Recall Campaign

Daimler Trucks
North America LLC

FL761A-C

Subject: TBB Minotour Wheelchair Lift Interlock

Figure 2: Current Harness Installation

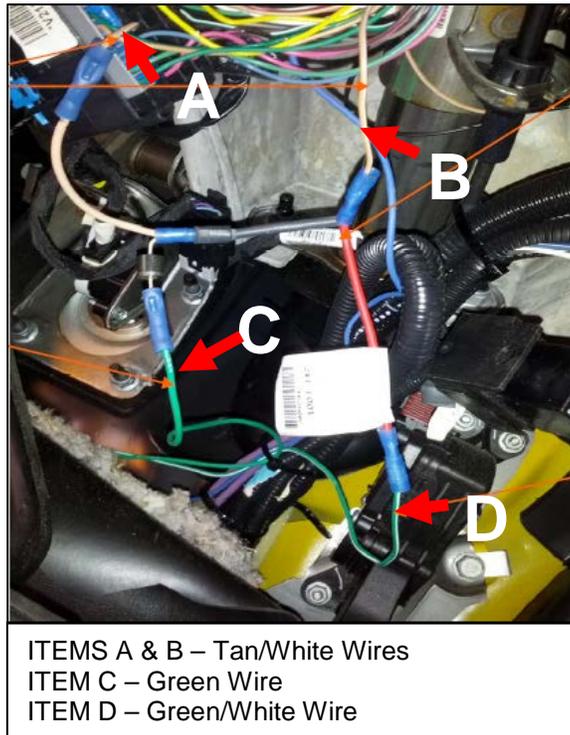
3. Cut the two brown wires between the connectors shown in **Figure 2 Items A and B** as close to the butt splice as possible (to allow connection to the new harness).
4. Install new harness TBB 175974 as shown in **Figures 2 and 3**.
 - 4.1 Connect the new harness to Positions A and B, where the brown wires were cut.
 - 4.2 Connect the existing green wire to Position C on the new harness.
 - 4.3 Connect the existing green/white wire to Position D on the new harness.
5. Repeat the inspection procedure.

Figure 4: View of PC Boards

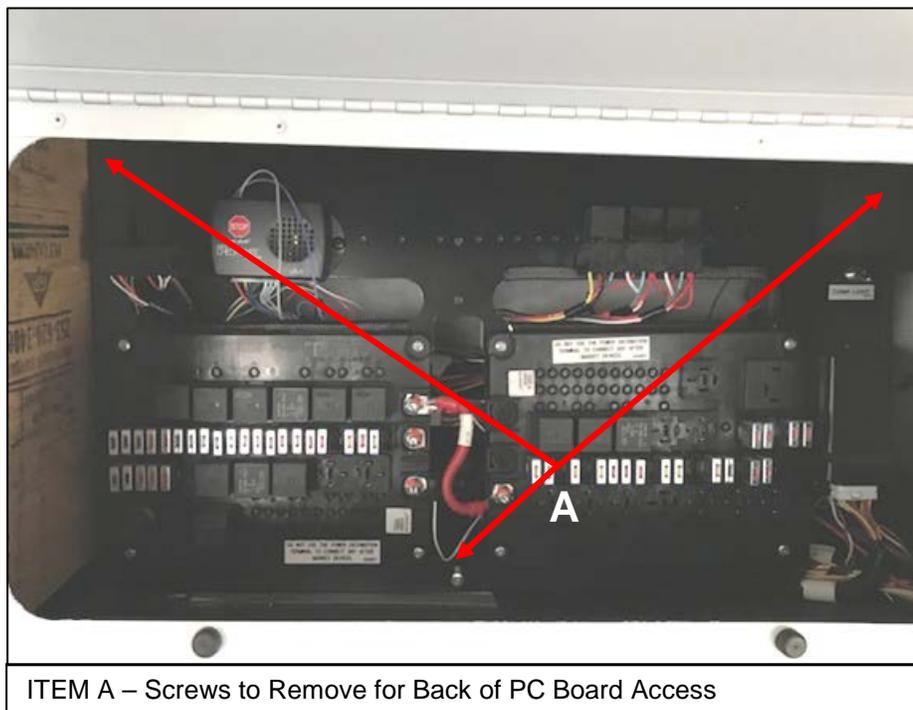
1. If necessary, park the vehicle, shut down the engine, place in park, set the parking brake, and chock the tires.
2. Remove the panel just below steering column. Using a 10 mm socket, remove the two screws underneath the panel. See **Figure 1**.
3. Compare the connections to **Figure 2**.
If the connections are the same, continue with the next step.
If the connections are different, install TBB 175974 (HARNESS, LIFT INTERLOCK, 2012 GMC) and perform the inspection and repair for FL761A&C. Go to *FL761A & FL761C – Wheelchair Lift Interlock Inspection (Standard Operation)*.
4. Open the PC circuit board cabinet (above the driver's seat) and prop the door open. See **Figure 4**.
5. Remove the three screws indicated in **Figure 4** and lay the PC board down.

Figure 7: Rear of PC Boards Showing Connections, Only

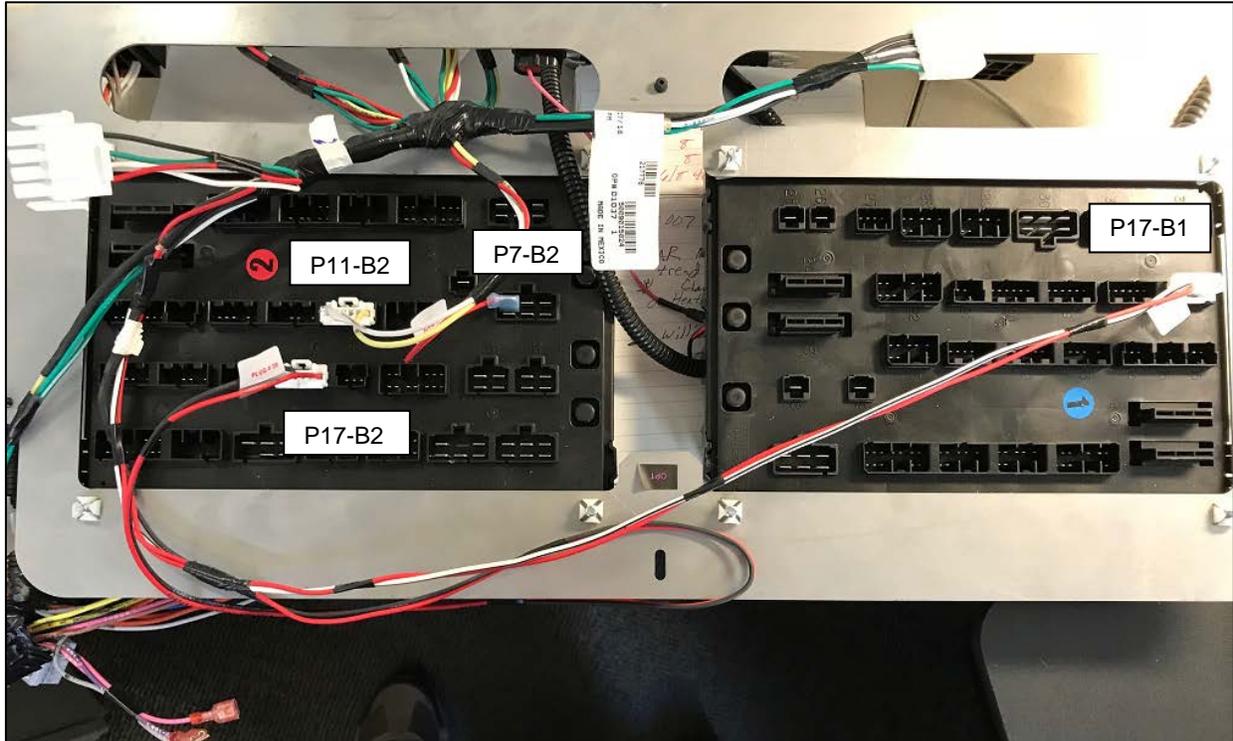
7. Remove the existing harness and install the new harness TBB 217778. The old and new harnesses have the same connection points on the back of the boards and connecting harnesses. **Figure 7** shows the locations on the back of the PC board. The remaining plugs on the harness will be connected to harnesses that are not plugged into the PC boards.
